BOXING BEAR BREWING COMPANY
NEW SHADE CANOPY
12501 CANDELARIA ROAD NE
ALBUQUERQUE NM 87112

TO: Treveston Elliott Architect
FROM: Leroy Duarte, Staff Planner
City of Albuquerque Planning Department
TEL: (505) 924-3452
RE: AA PR-20219-002237 12501 Candelaria Rd. NE- Bridges on Tramway

I am the Staff Planner reviewing your application for project #2019-002237, an Administrative Amendment at 12501 Candelaria Rd. NE for a shade canopy over existing patio on site.

A-083

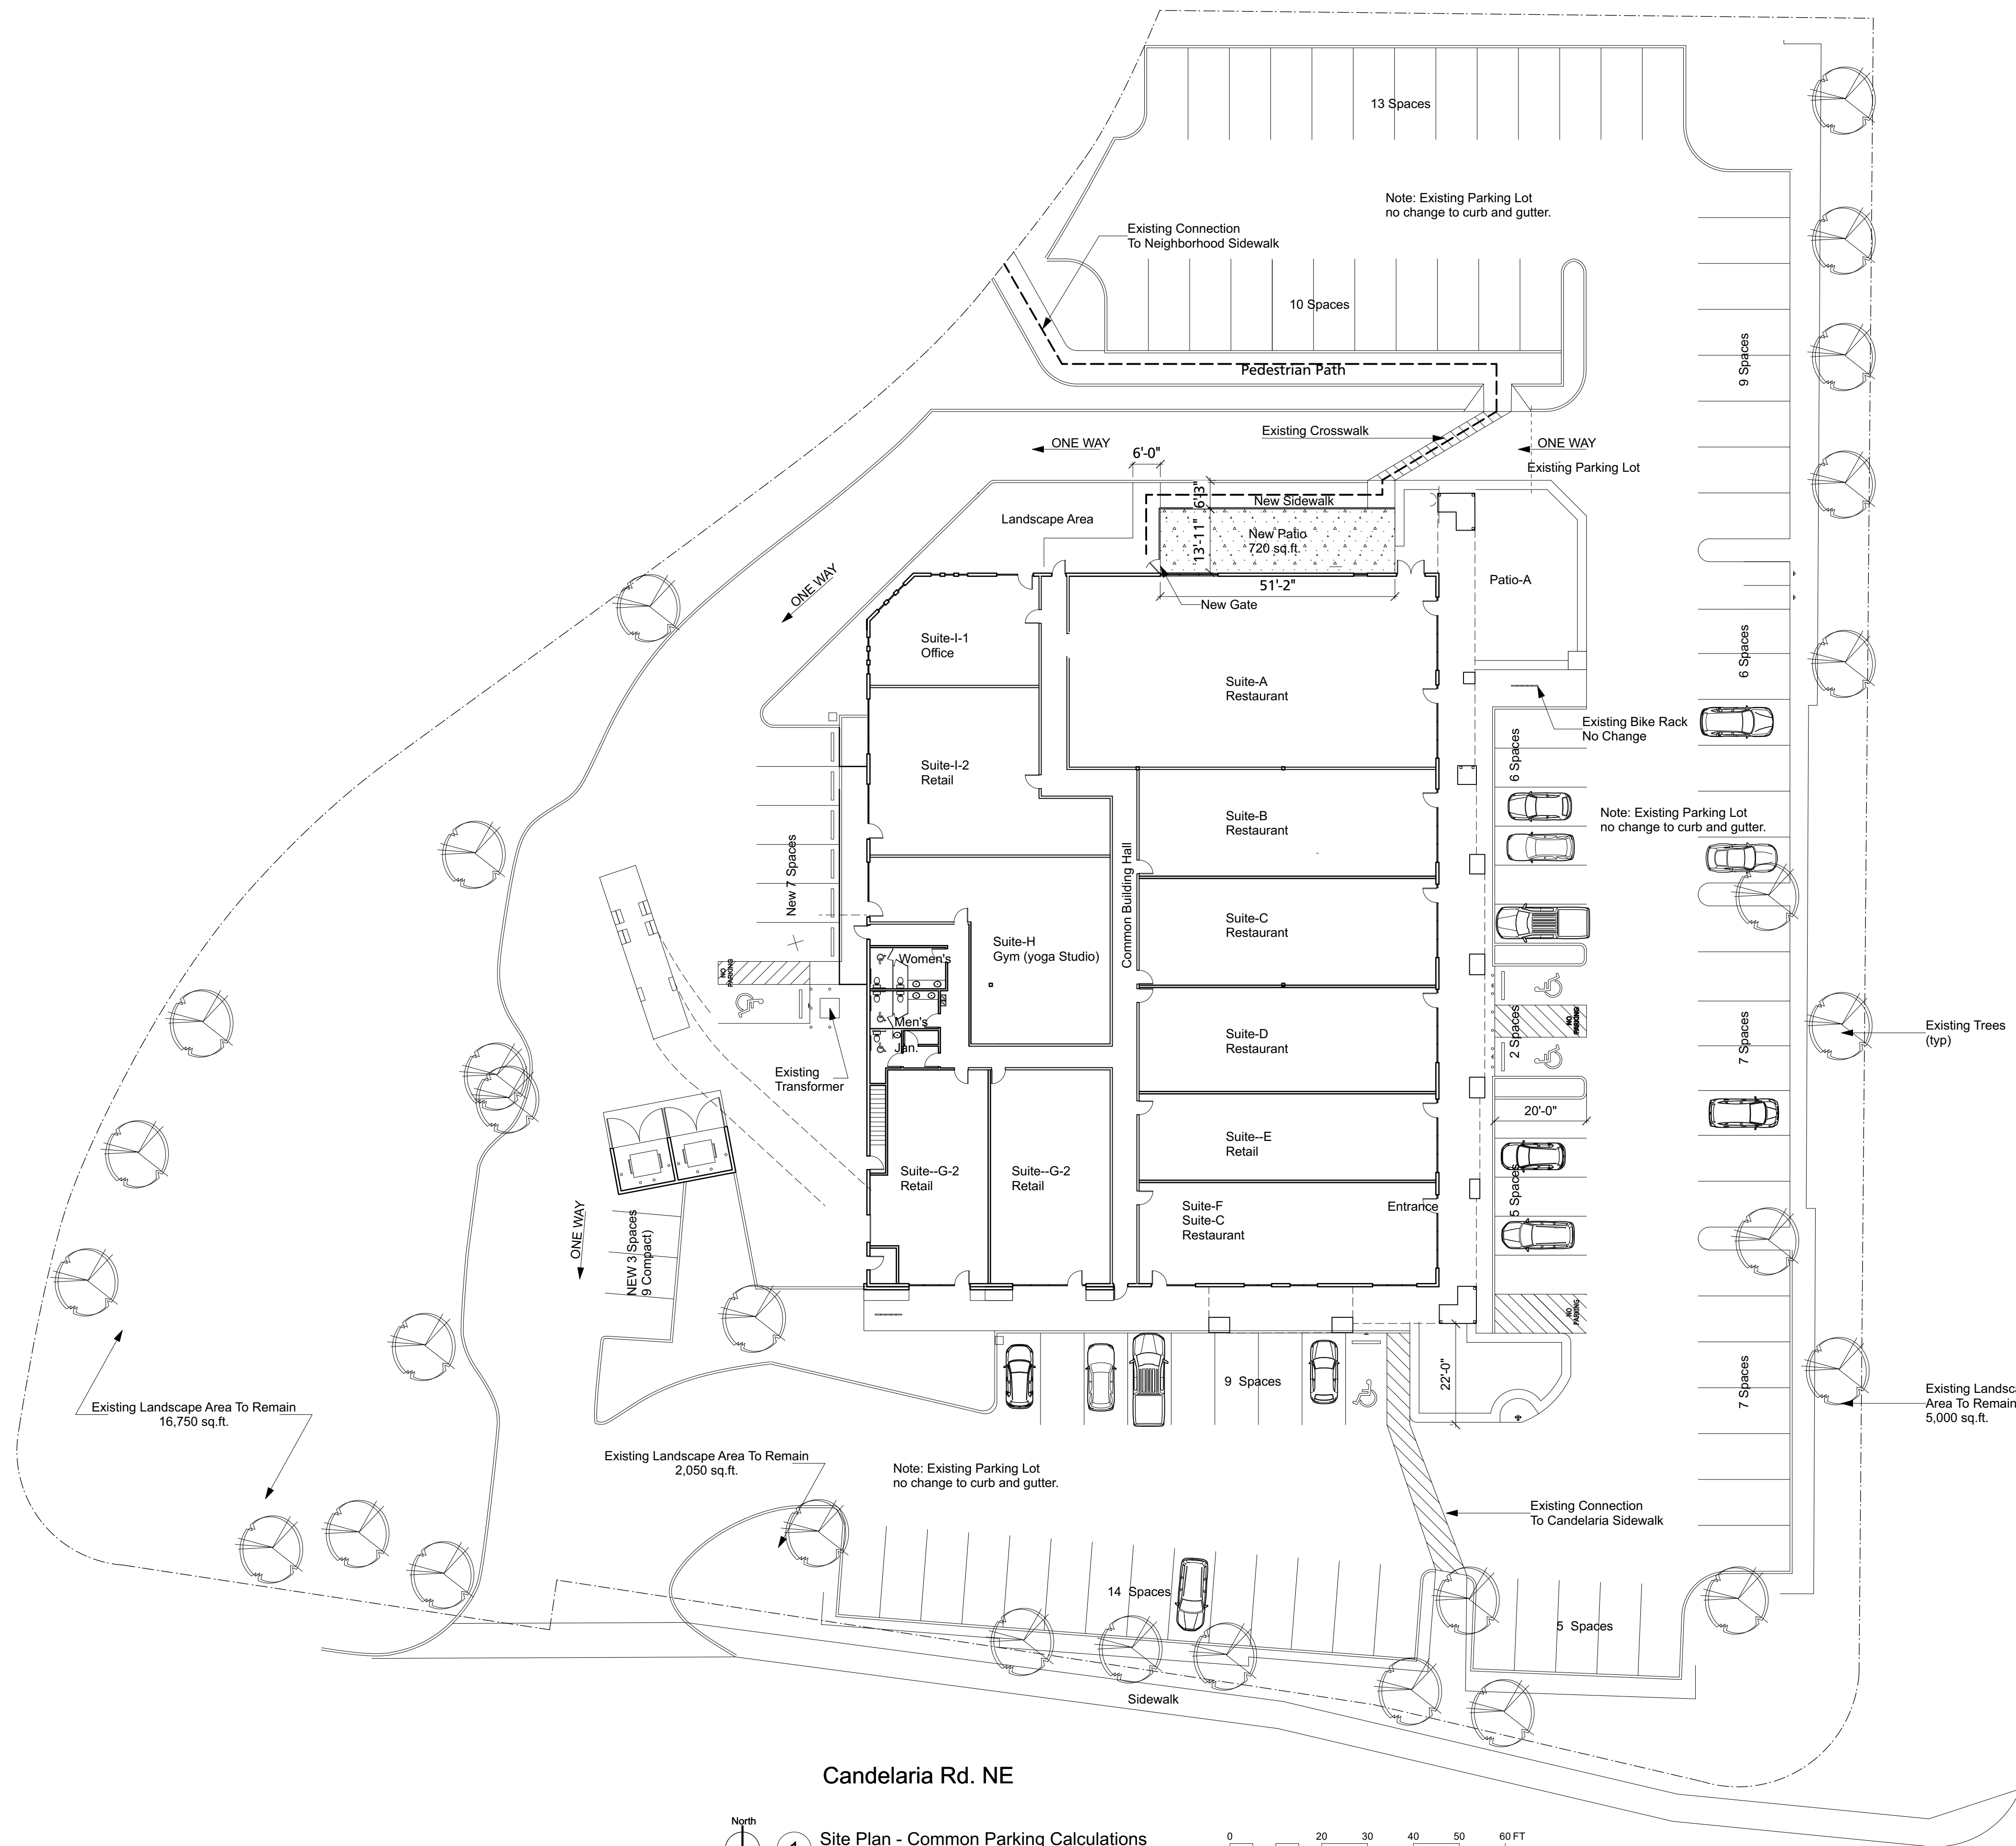
Please address the drawings A-081 and A-083. A-081 drawings show new sidewalk abutting building, whereas on drawing A-083 patio is enclosed. Please clarify proposed patio and new sidewalk.

S1

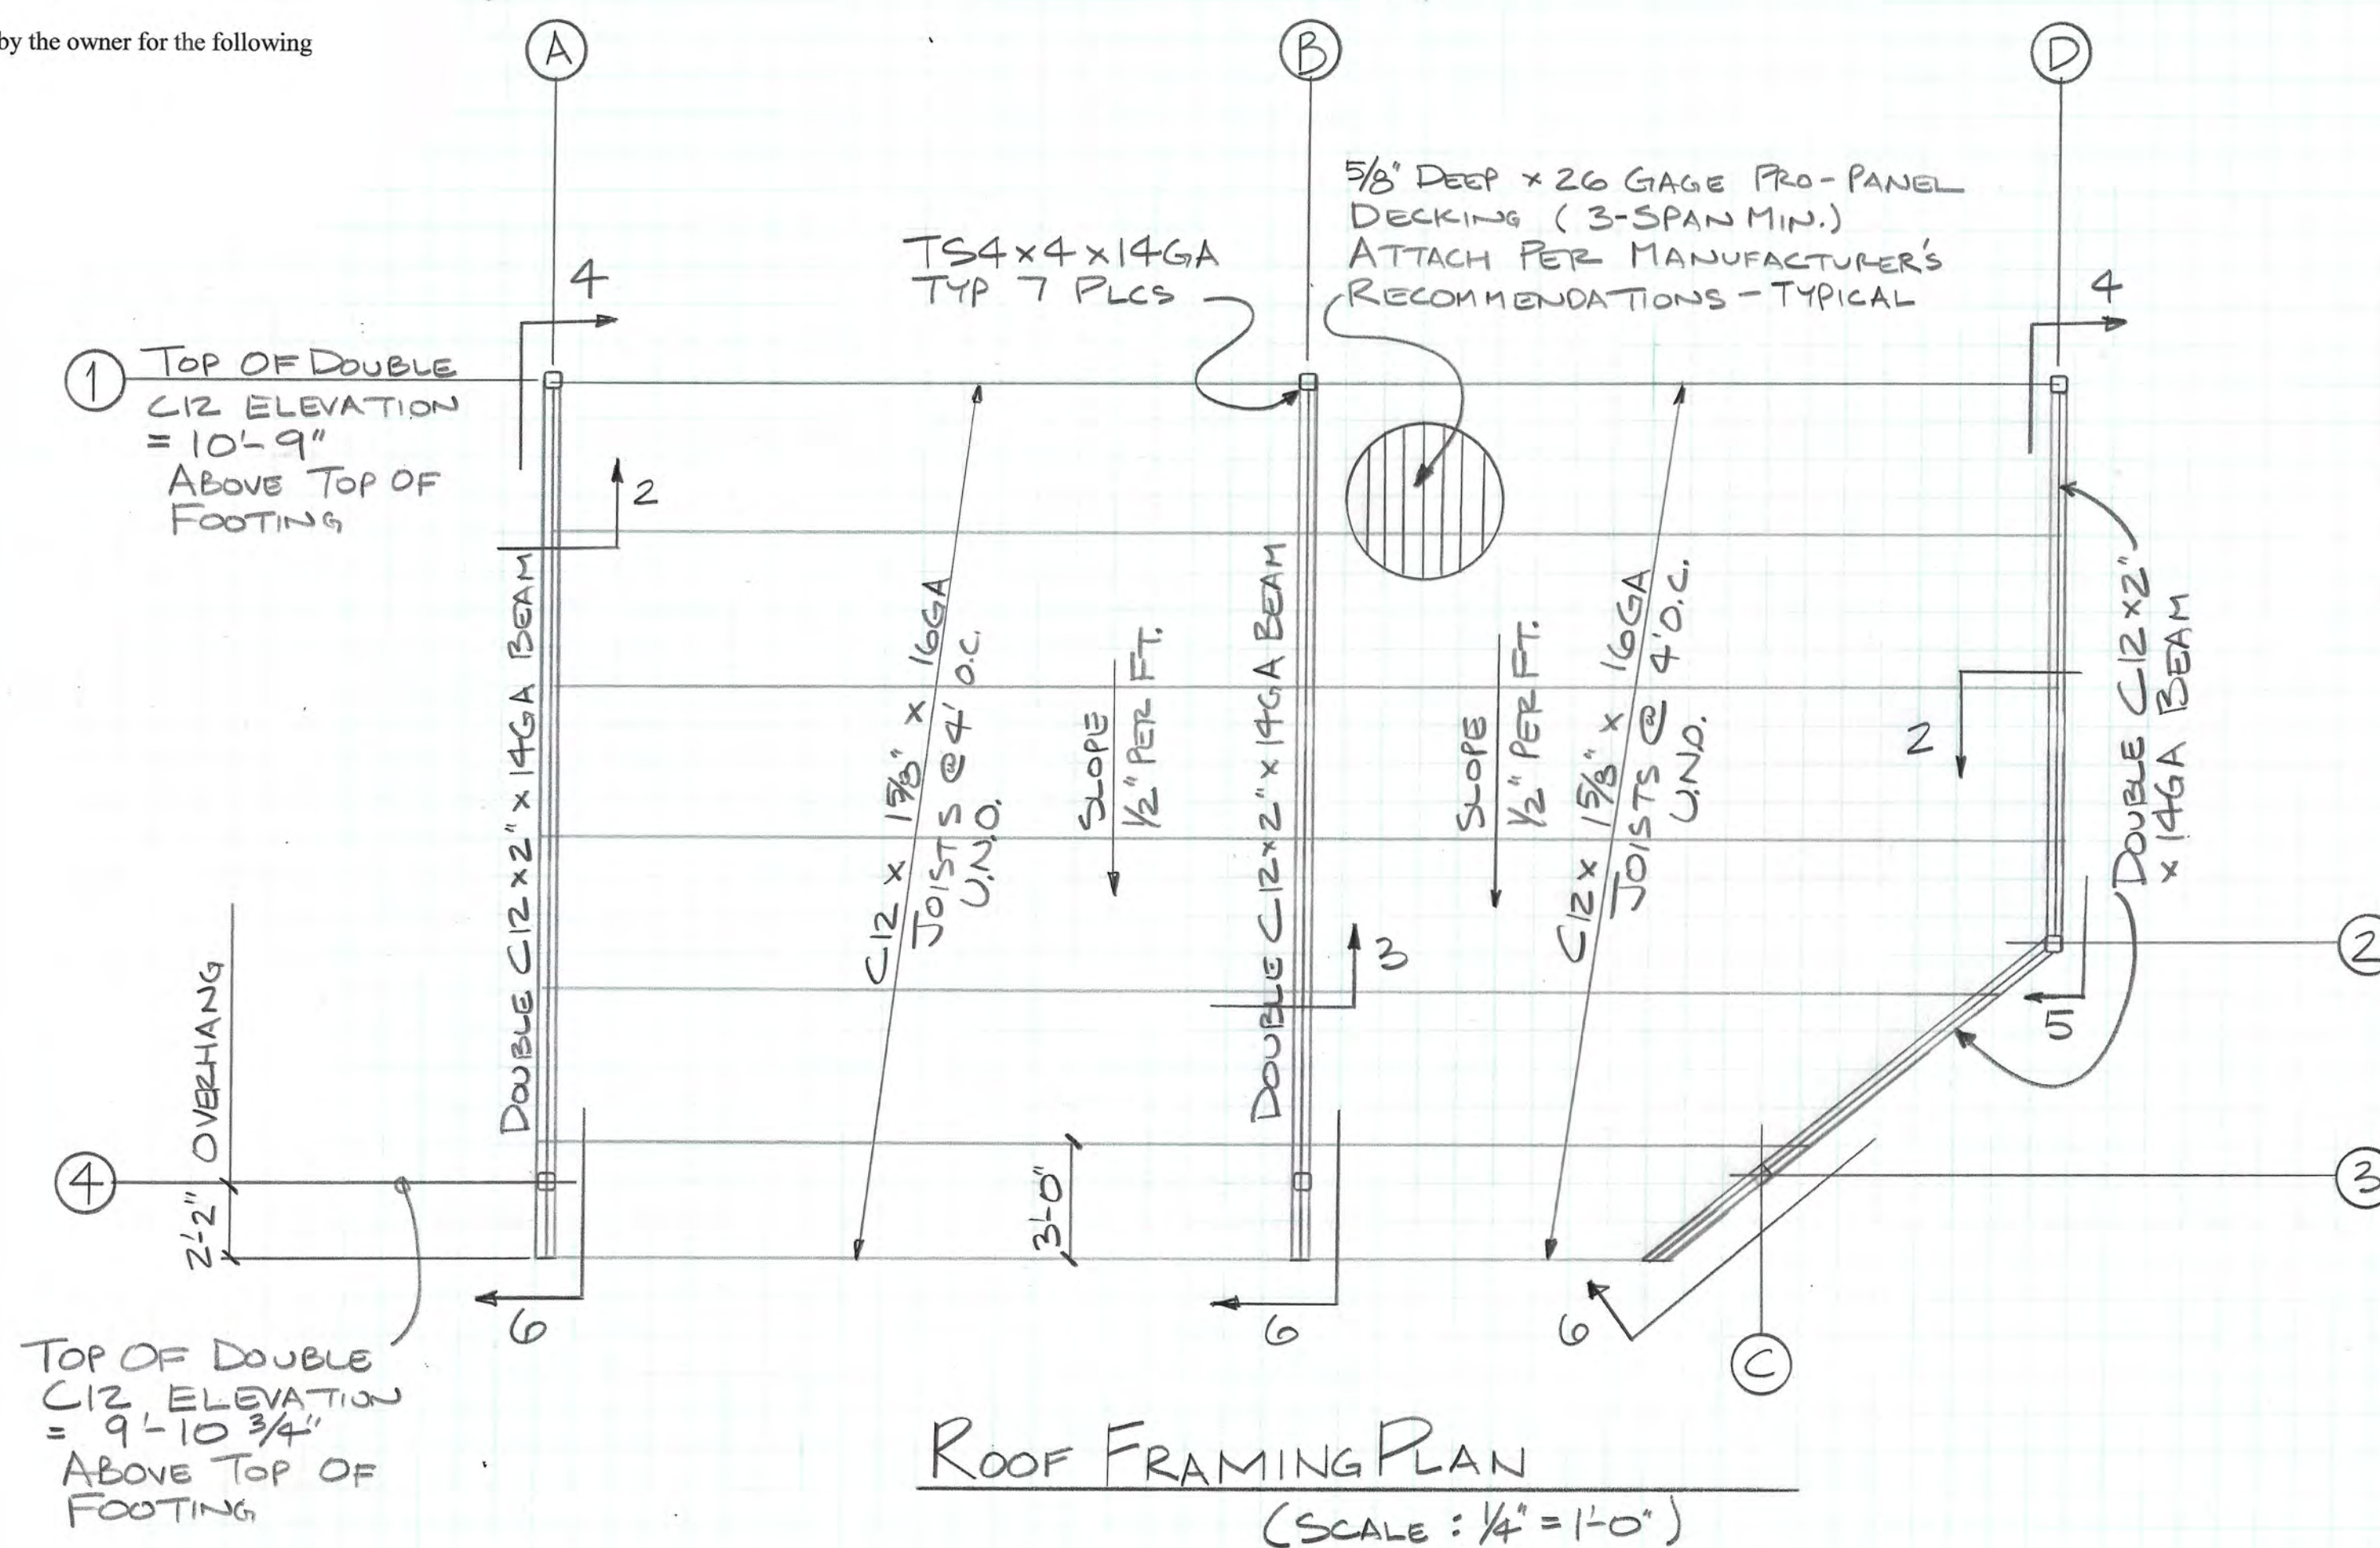
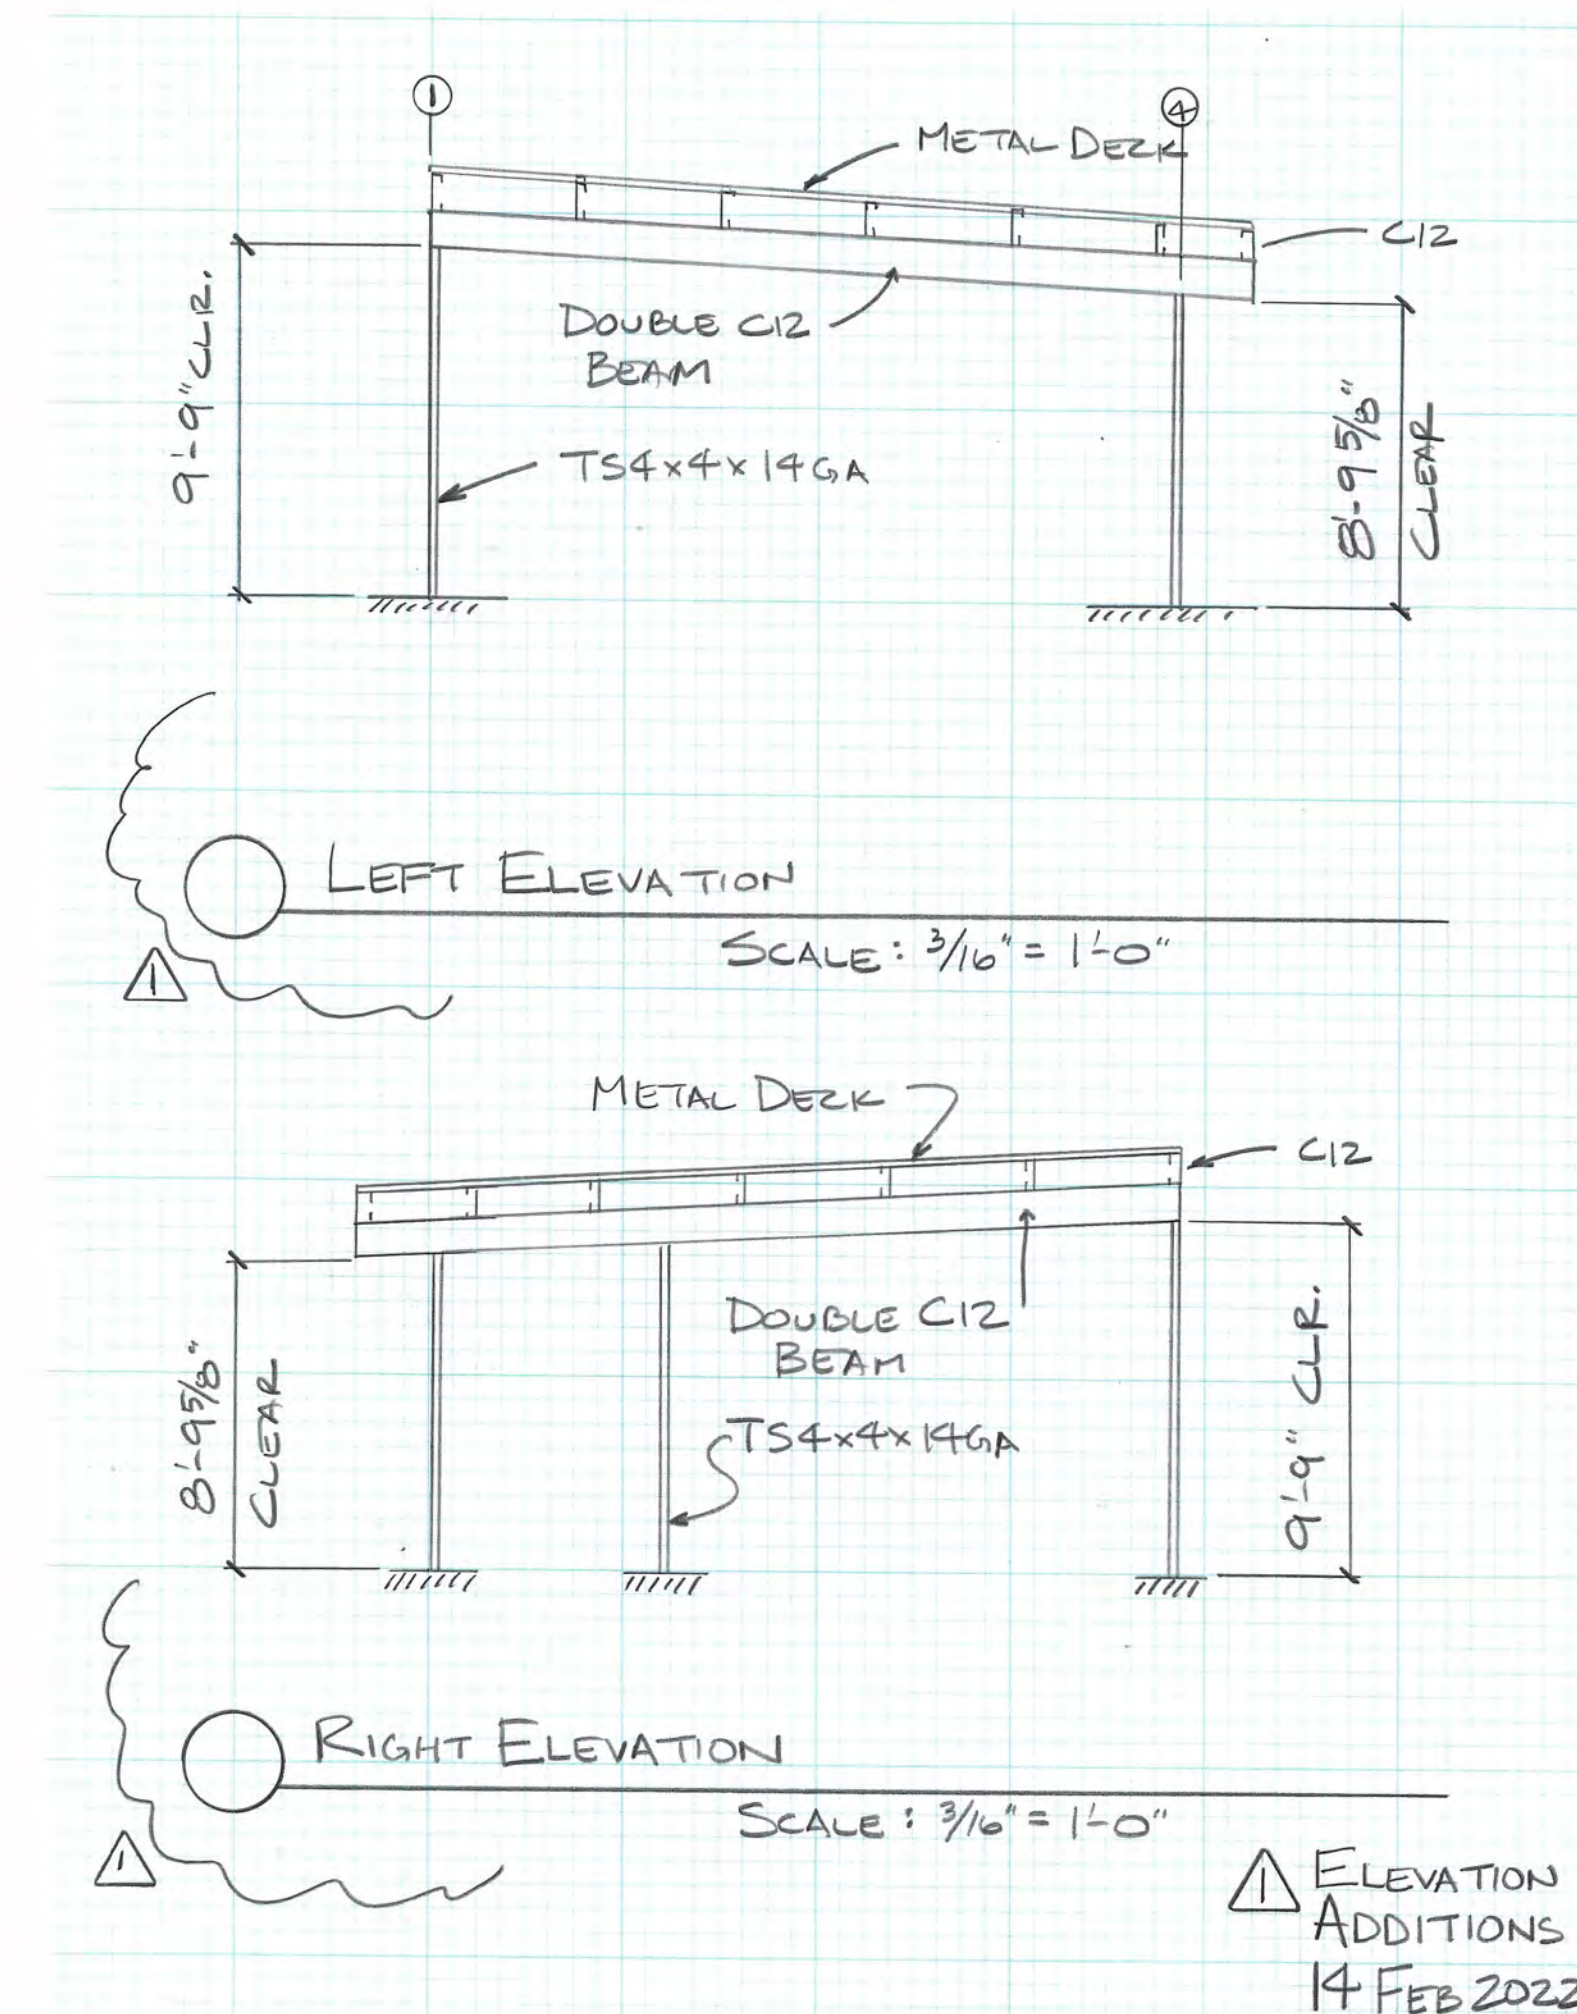
Please show proposed covered patio drawings/details.
